**Old Connaught Phase
A1 LRD: Road Safety
Audit Stage 1**

Castlethorn Old Conna ULC

September 2026

012644DG0022

Figure 2-1 – Sight Lines at Entrance

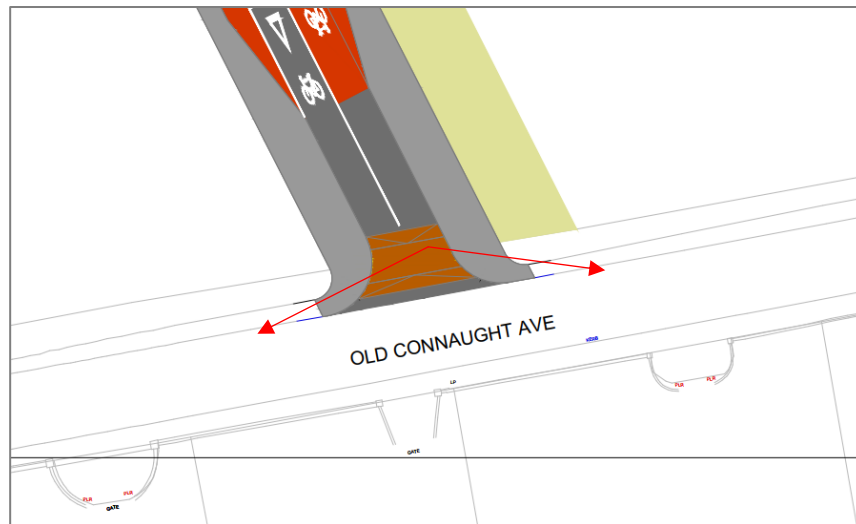
It is unclear if there are sufficient sight lines to the left and right of the entrance to the development along Old Connaught Avenue. Restricted visibility splays at the development entrance could result in vehicle collisions due to insufficient visibility provisions for motorists entering and exiting the development junction.

The designer should provide visibility splays to Standard at the development entrance junction.

Figure 2-2 – Vehicle Stacking Length at Entrance

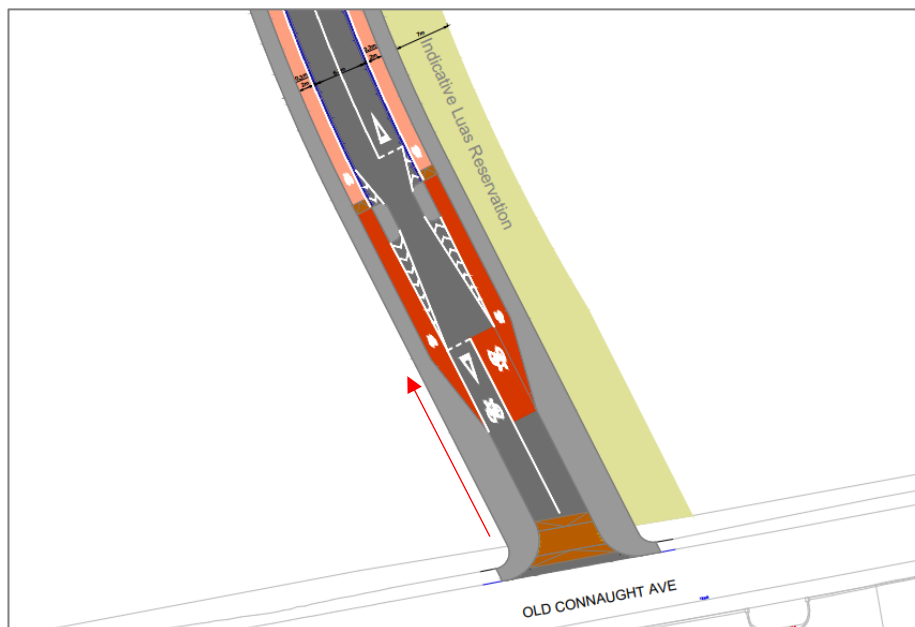
It is unclear if sufficient stacking distance is provided for vehicles entering the development ahead of the yield markings at the entrance to the development. If the traffic volumes entering the development is high, it might result in vehicles stacking into Old Connaught Avenue, resulting in potential rear-end collisions as a result of vehicles, particularly where there may be visibility issues.

The designer should ensure that a sufficient stacking length is provided ahead of the yield sign for vehicles entering the development.

2.1	Yes	Yes		-
2.2	Yes	No	A 24 m stacking length has been provided within the current design to accommodate anticipated vehicle demand while reducing the length of shared carriageway used by both cyclists and vehicles. This arrangement is proposed as an interim measure and will be superseded by a signal-controlled junction incorporating dedicated cycling facilities as part of the ultimate scheme.	Yes

Figure 2-3 – Vehicle Queue Length at Entrance

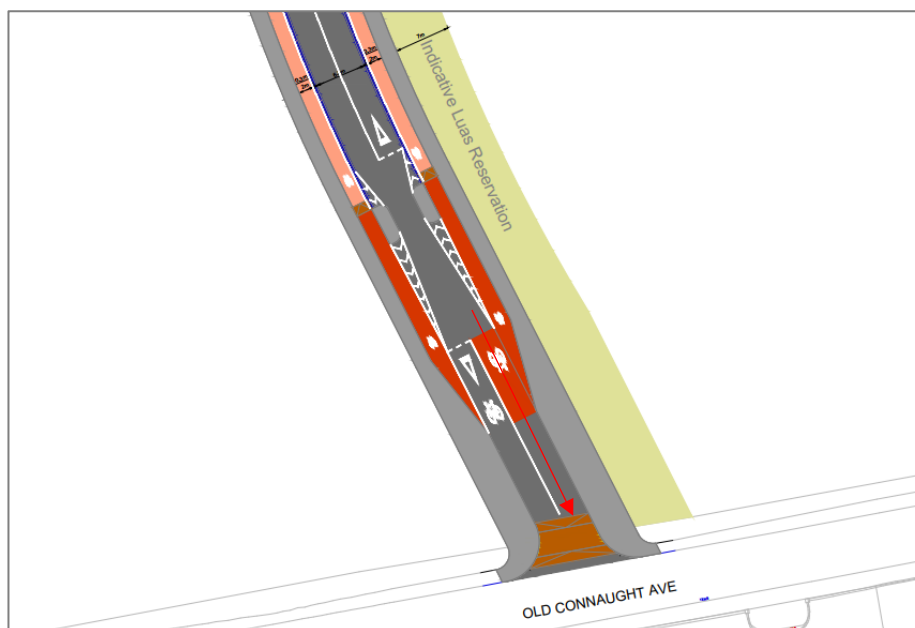
It is unclear if sufficient queueing distance is provided for vehicles exiting the development onto Old Connaught Avenue. If the traffic volumes exiting the development is high, it might result in vehicles stacking into the pinch point along NS Road, resulting in potential vehicle conflict.

The designer should ensure that a sufficient queueing length is provided ahead of the Old Connaught Avenue junction for vehicles exiting the development.

2.3	Yes	No	A 24 m queue length has been provided within the current design to accommodate anticipated vehicle demand while reducing the length of shared carriageway used by both cyclists and vehicles. This arrangement is proposed as an interim measure and will be superseded by a signal-controlled junction incorporating dedicated cycling facilities as part of the ultimate scheme.	Yes

Figure 2-4 – Large Corner Radii

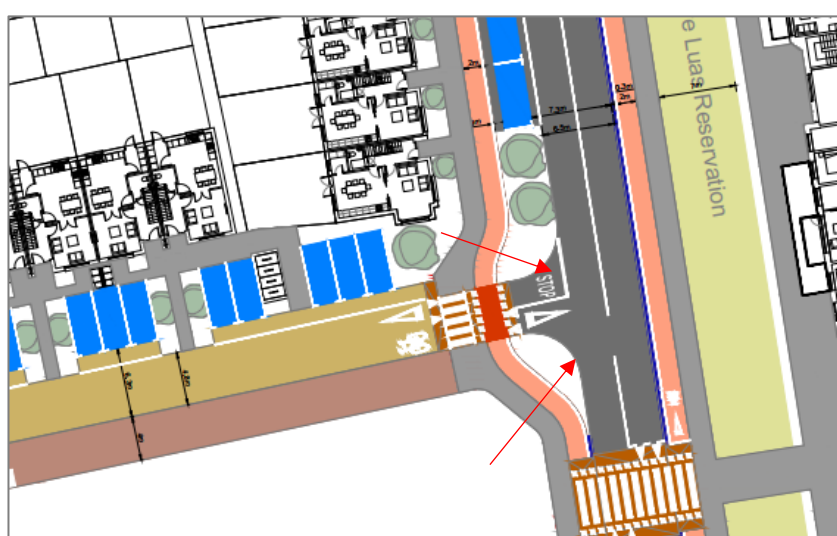
The corner radii at junctions within the development appear to be large, which might encourage higher entry/exit speeds along the development roads. This could result in conflict between motorists and pedestrians.

The designer should ensure that the corner radii at junctions within the development are small enough to slow vehicles down for the safety of all users within the development.

2.4	Yes	No	The junctions have been designed with 4.5 m corner radii, which are in accordance with DMURS recommendations for local streets, to provide a low-speed environment while accommodating service, refuse and emergency vehicles.	Yes

Figure 2-7 – Example of lack of provisions for Visually Impaired Pedestrians

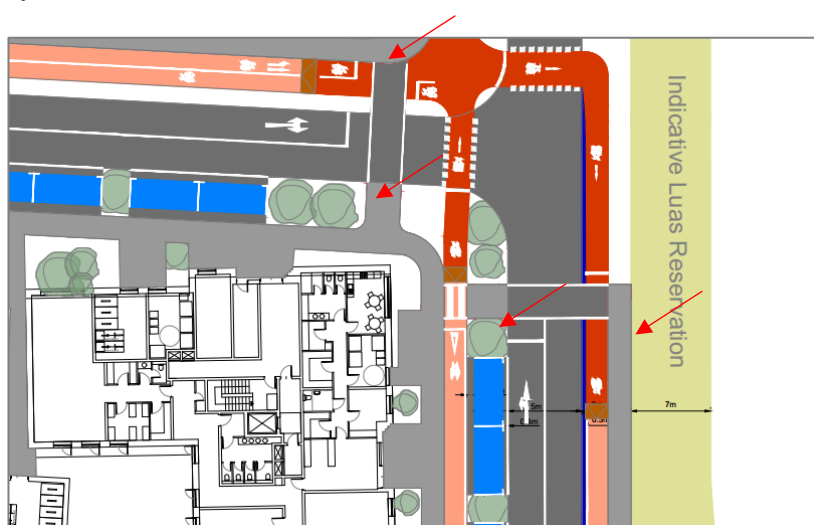
There are no tactile paving provisions on footpaths throughout the development, which could lead to confusion for visually impaired pedestrians along the scheme. This could result in pedestrians coming into conflict with cyclists and motorists.

The designer should provide tactile paving to standard, for visually impaired pedestrians.

Figure 2-8 – Abrupt End to Footpath

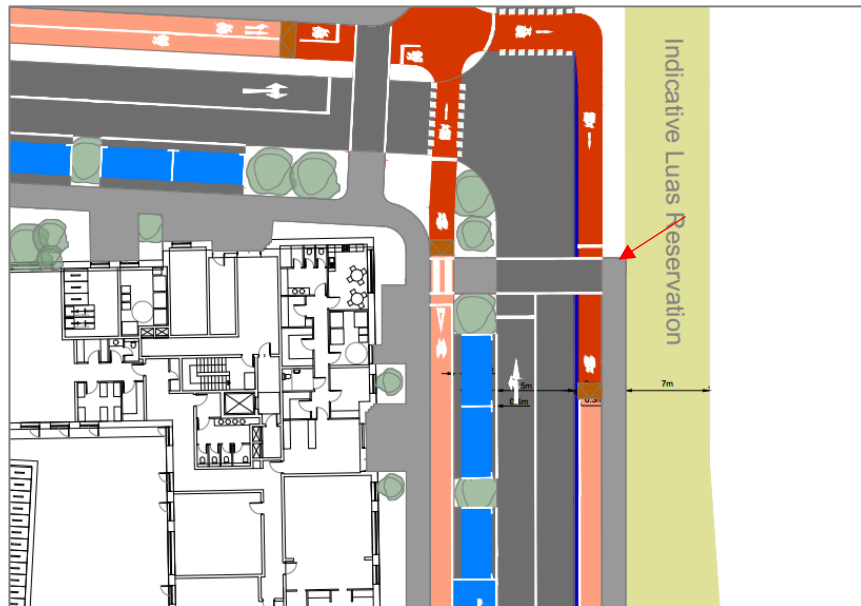
The eastern footpath at the northern end of NS Road ends abruptly with no indications for further pedestrian movement. This could result in pedestrian confusion, especially visually impaired users, resulting in potential conflict between pedestrians and cyclists/vehicles.

The designer should provide clear indications of the travel direction and provide adequate measures to assist visually impaired pedestrians in navigating the stopped end of the footpath.

Figure 2-9 – Cycle Path Alignment

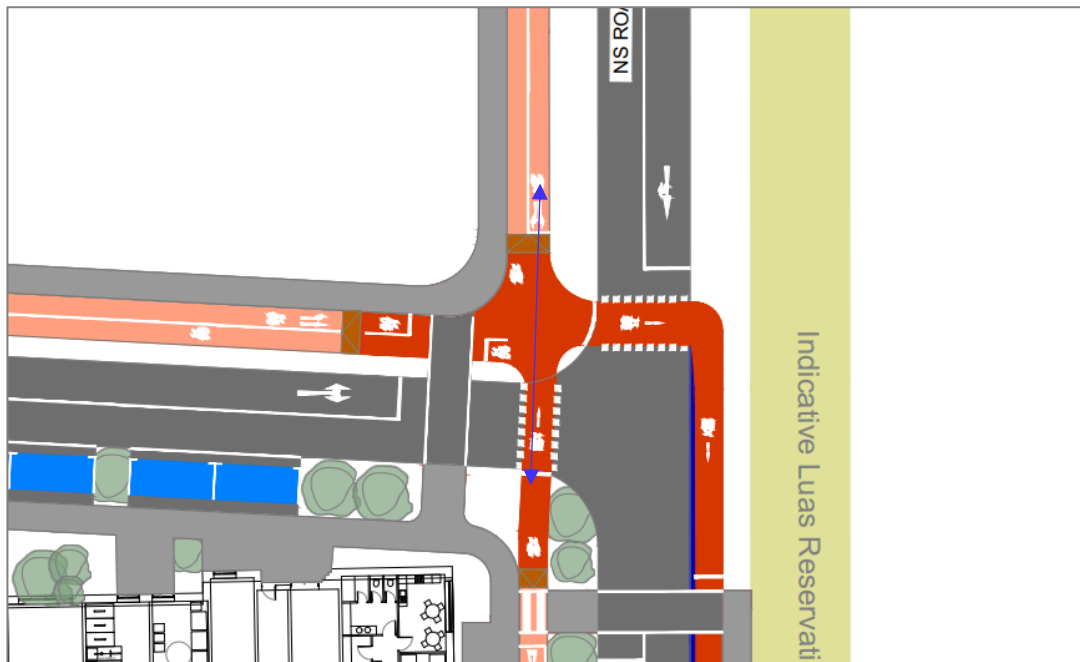
The northbound cycle path at the northern end of NS Road is aligned in a manner that could result in cyclists moving northward (after crossing EW road) coming into conflict with cyclists traveling southbound along the cycle path at the northern end of NS Road, and vice versa.

The designer should align the northern cycle path in a way which ensures that the northbound cycle path is aligned throughout (before and after crossing the junction).

2.7	Yes	Yes		-
2.8	Yes	Yes		-
2.9	Yes	No	Road markings will be revised to provide clearer guidance to cyclists and direct them into the appropriate lane arrangement.	Yes

Figure 2-11 – Road Markings for the NS Road / Old Connaught Avenue

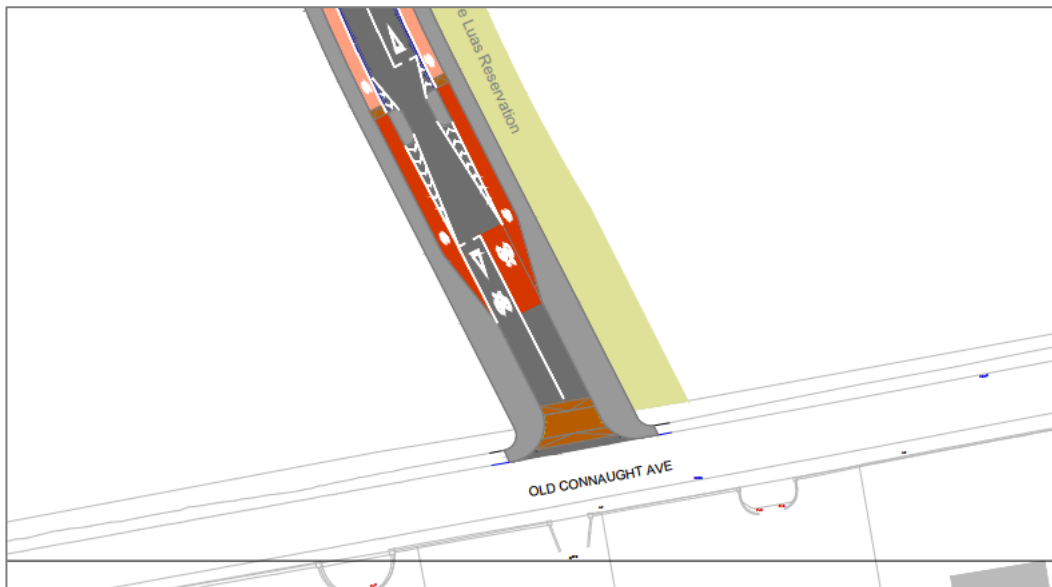
Road markings for the NS Road / Old Connaught Avenue are not indicated. This results in uncertainty about pedestrian/vehicular priority at the junction. There is no indication that vehicles should Stop for Old Connaught Avenue traffic, which could result in collisions.

The design team should ensure that road markings for the NS Road / Old Connaught Avenue are provided to indicate pedestrian/vehicular priority and that vehicles should Stop for Old Connaught Avenue traffic.

Figure 2-12 – Cyclist Access to Crossing

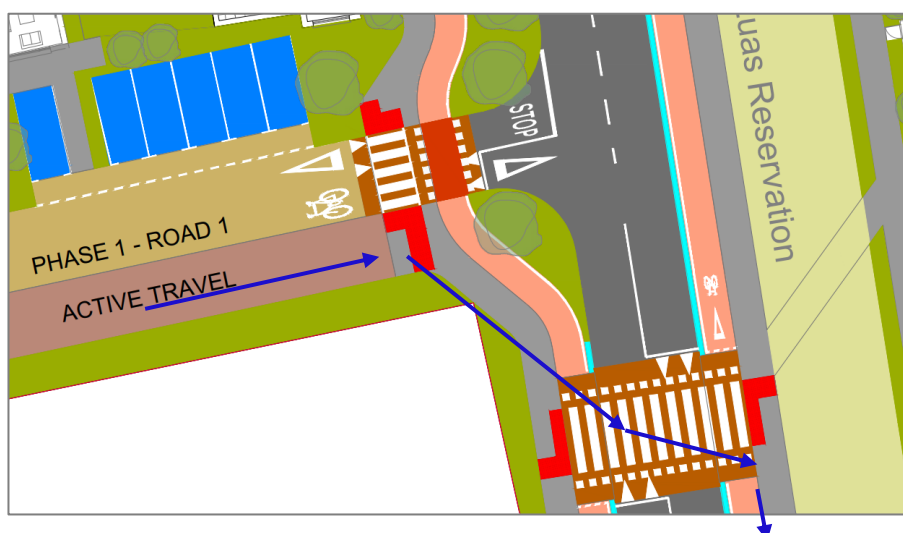
The current layout of the NS Link Street / Phase A1 Road 1 Southern Link junction requires cyclists traveling along the active travel area to traverse pedestrian and oncoming cyclist facilities in order to cross NS Link Street to access the southbound cycle lane along NS Link Street. Additionally, northbound cyclists wishing to turn left into or out of the active travel area have no provision. This could result in collisions between cyclists and pedestrians/other cyclists.

The design team should ensure that a suitable arrangement is provided to safely facilitate all movements.

2.12	Yes	Yes		-
2.13	Yes	Yes	During the detailed design stage, the existing segregated facility located between the Active Travel facility and the pedestrian crossing on the North–South Link Road will be upgraded to a shared surface arrangement.	-

Figure 2-13 – Visibility of Signal Heads at Crossings

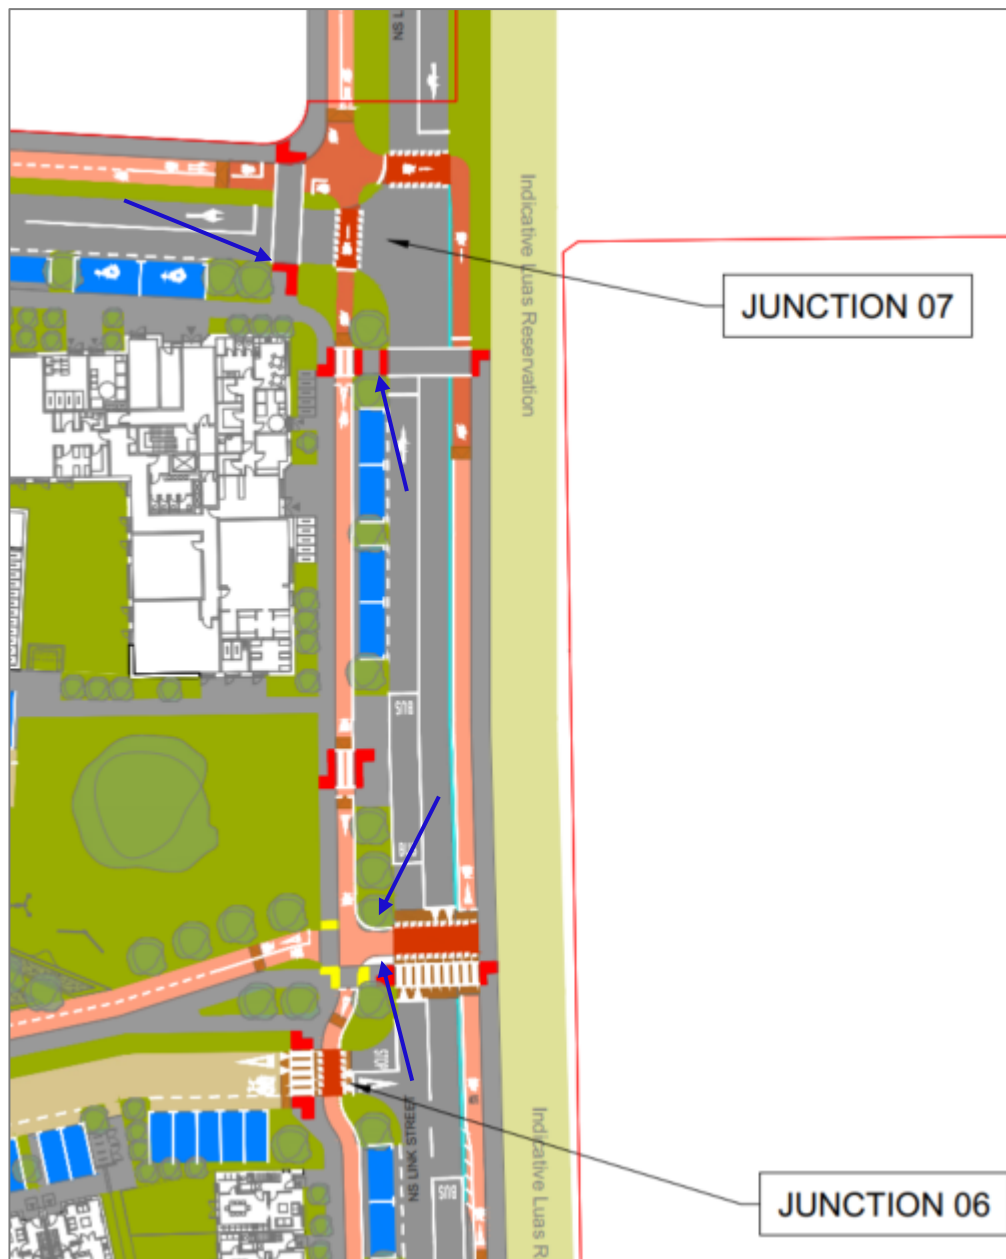
The current tree provisions at the EW Link Street / NS Link Street Crossing as well as the Phase A1 – Road A / NS Link Street Crossing could potentially restrict the visibility of motorists along EW Link Street and NS Link Street to observe the crossing signal heads at both crossings. This could result in motorist/pedestrian collisions.

The design team should ensure that visibility to signal heads is to standard for motorists approaching crossings.

2.14	Yes	Yes	During the detailed design stage, the proposed tree planting will be reviewed to ensure that adequate visibility is maintained. Trees of appropriate size will be selected or relocated/removed where necessary to achieve the required visibility standards.	-

Figure 2-14 – Visibility of Pedestrians/Cyclists at Crossing

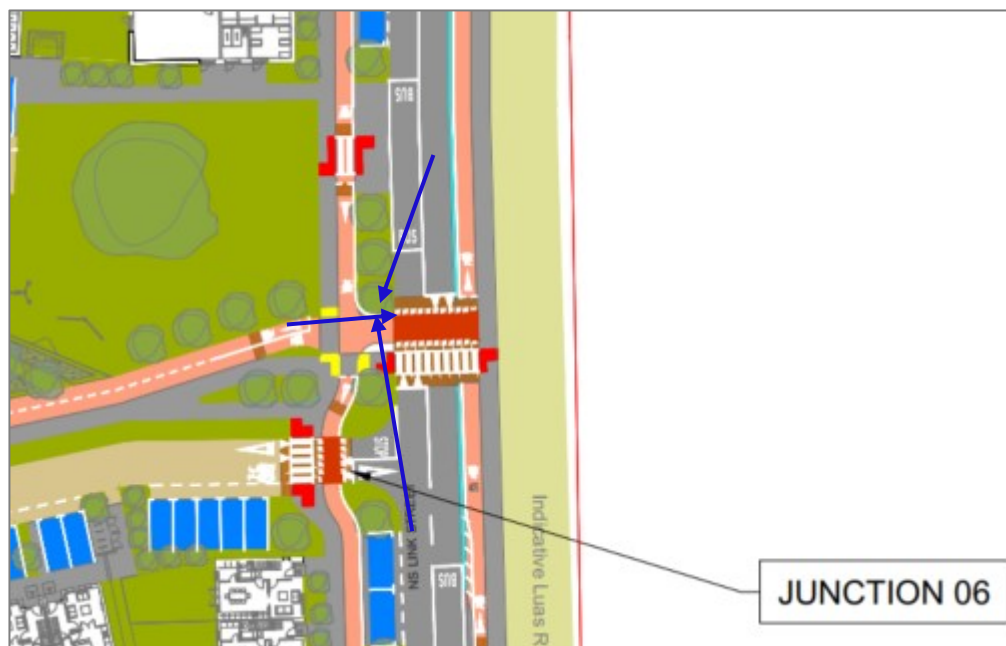
The current tree provisions at the Phase A1 – Road A / NS Link Street Crossing could potentially restrict the visibility of motorists along NS Link Street to observe cyclists and pedestrians approaching the crossing. This could result in motorist/pedestrian collisions.

The design team should ensure that pedestrians and cyclists approaching the crossing are visible to motorists approaching crossings over a distance to Standard.

2.15	Yes	Yes	During the detailed design stage, the proposed tree planting will be reviewed to ensure that adequate visibility is maintained. Trees of appropriate size will be selected or relocated/removed where necessary to achieve the required visibility standards.	-

Figure 2-15 – Trees Restricting Visibility Splays

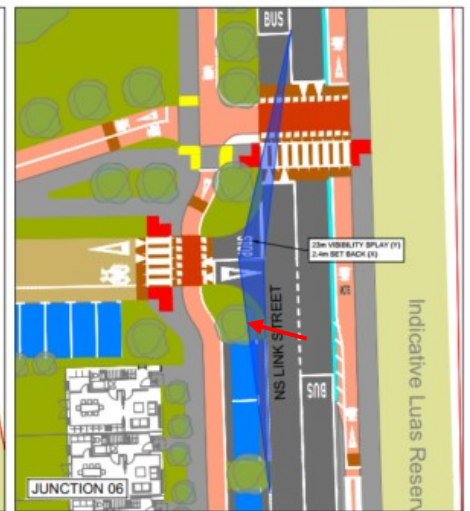
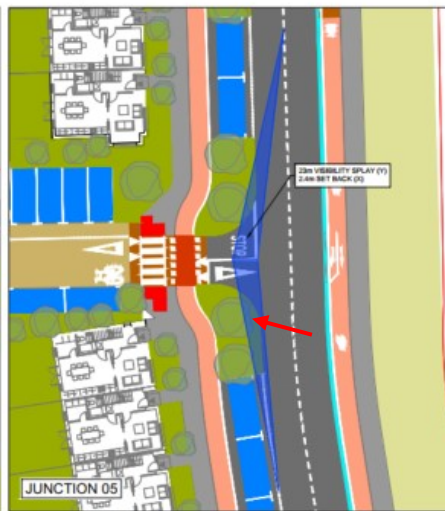
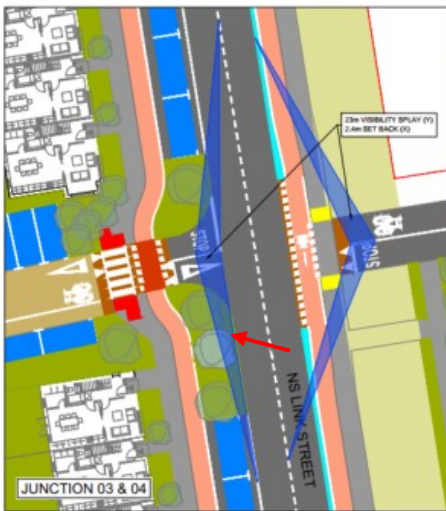
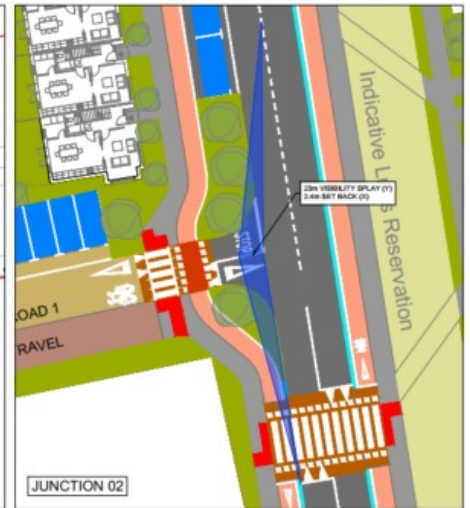
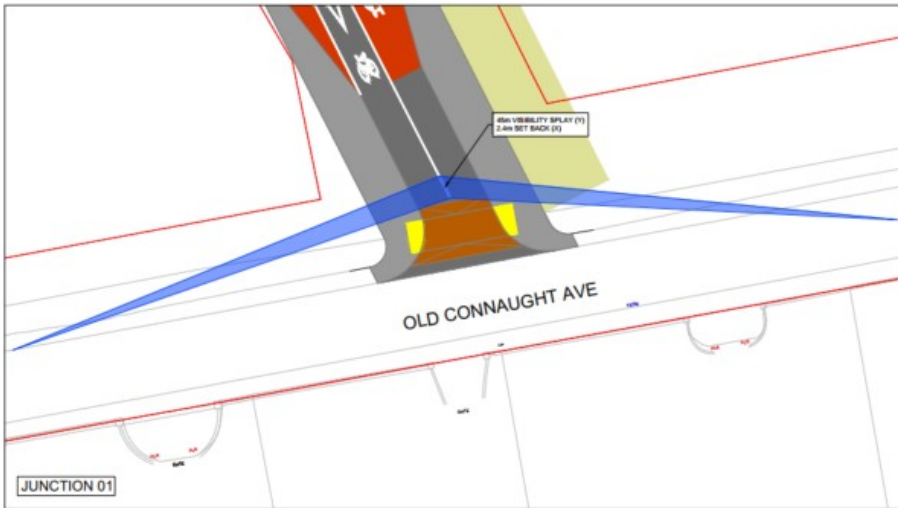
The current tree provisions at the junctions 3, 5, 6, 9, 10 and 11 restrict the y-distance visibility splays of motorists exiting the junctions. This could result in vehicle collisions.

The design team should ensure tree provisions do not restrict the visibility splays of vehicles within all junctions and that visibility splays at junctions throughout are to Standard.

2.16	Yes	Yes	During the detailed design stage, the proposed tree planting will be reviewed to ensure that adequate visibility is maintained. Trees of appropriate size will be selected or relocated/removed where necessary to achieve the required visibility standards.	-
